PCU060042

Re: Director General's Environmental Assessment Requirements (SSD 5722) for a proposed Waste and Resource Management Facility, Heathcote Road, Menai

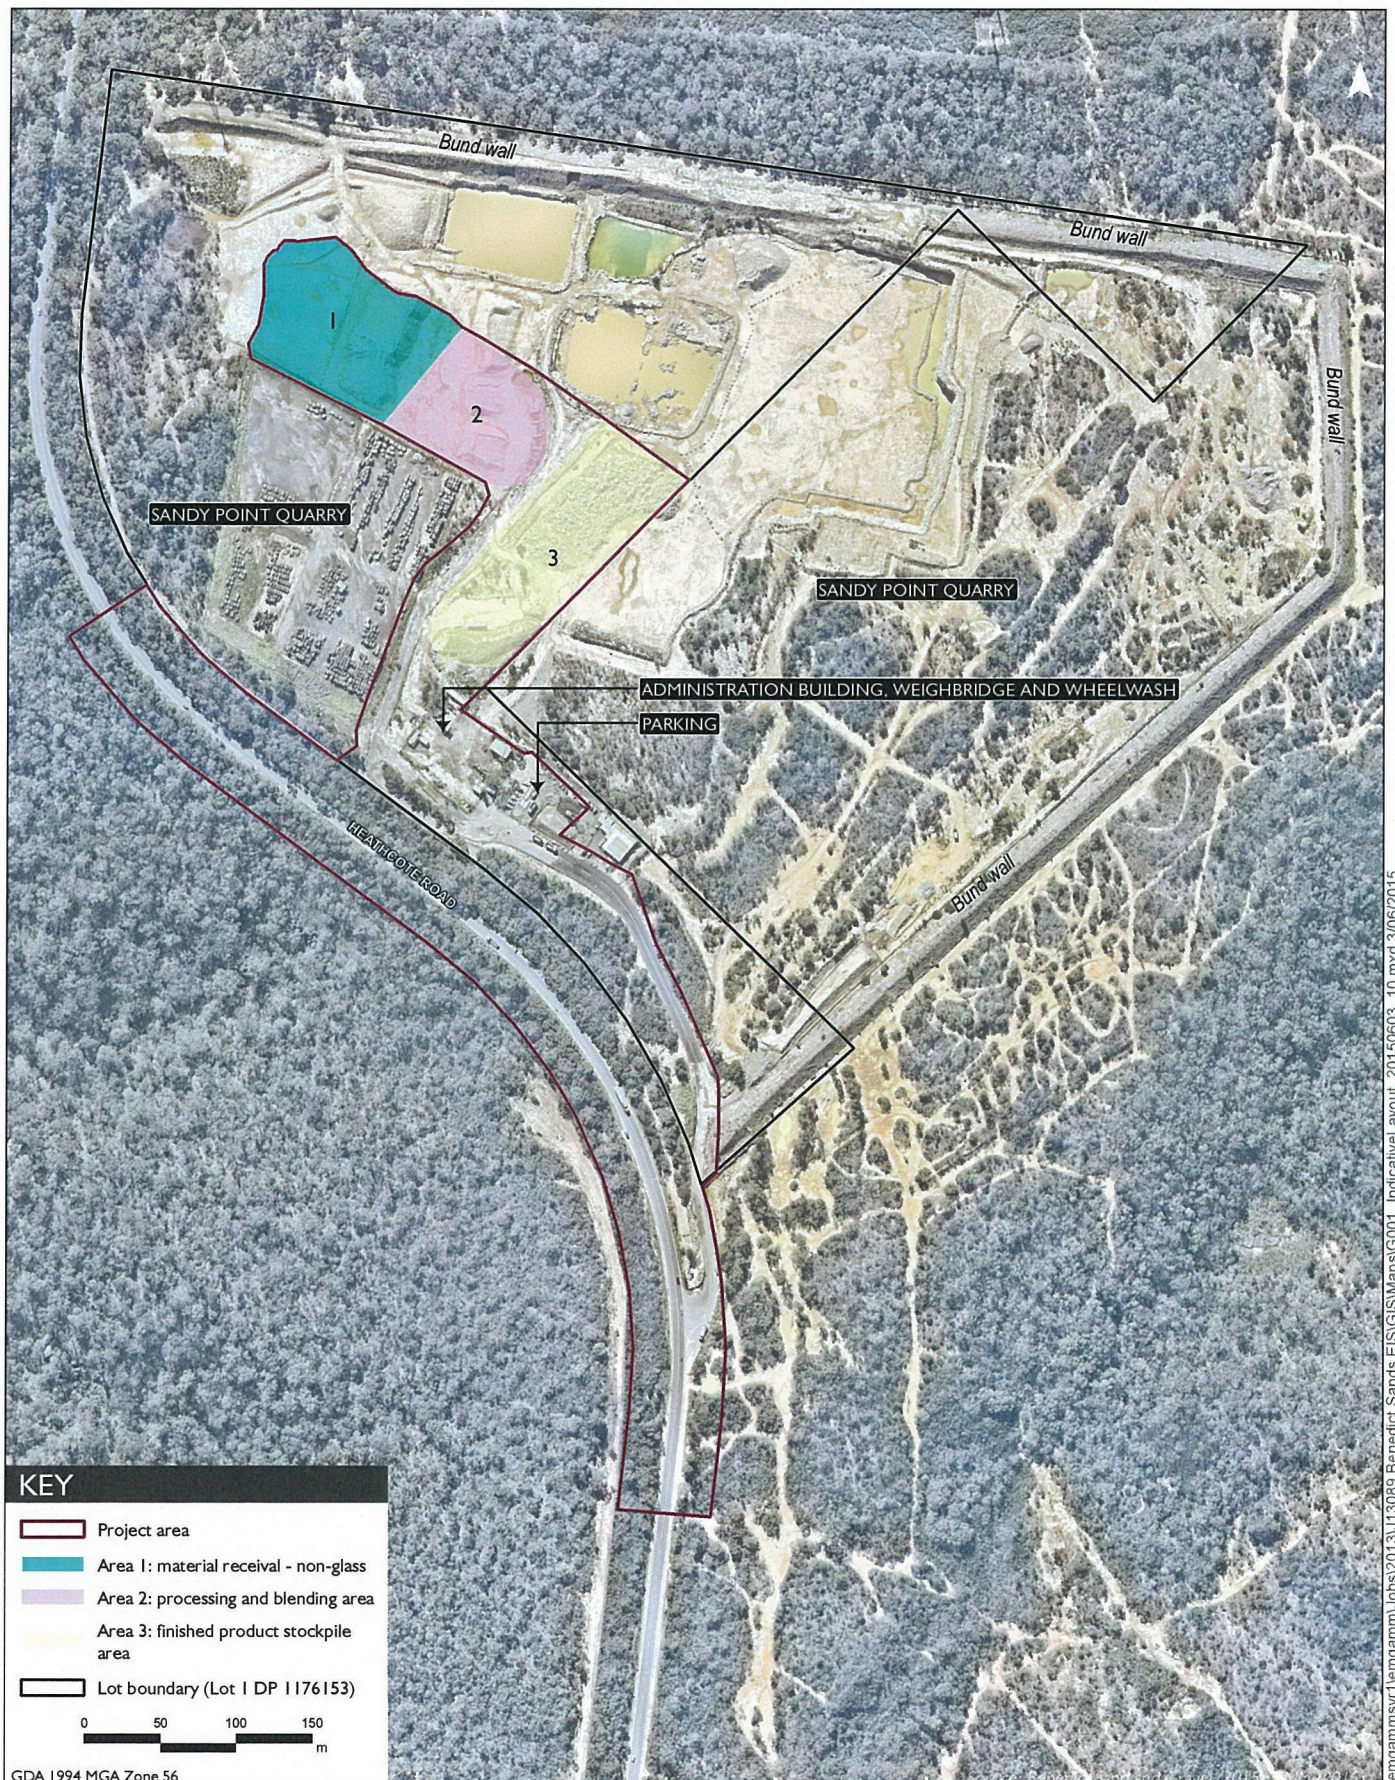
- EPA exempted products for use in blending.
- It is no longer proposed to accept glass, metals, timber, plasterboard or plastics.
 - The main components of the recycling facility will still be in previously cleared areas of the quarry (see attached figure):

- Area 1 (material receival area) where the imported inert waste will be received prior to processing.
 - Area 2 (processing area) where processing, including crushing and screening, of material from the quarry and imported inert waste will occur. It will also contain temporary stockpiles of processed material for blending and or transfer to the finished product stockpile area (Area 3). The area will contain a 9.5 m high silo for cement storage.

- Area 3 (finished product stockpile area) where finished product from Area 2 will be stockpiled for sampling and testing prior to dispatch.

The two glass storage and processing sheds are no longer proposed. Internal roads will be modified to reflect removing the glass processing area.
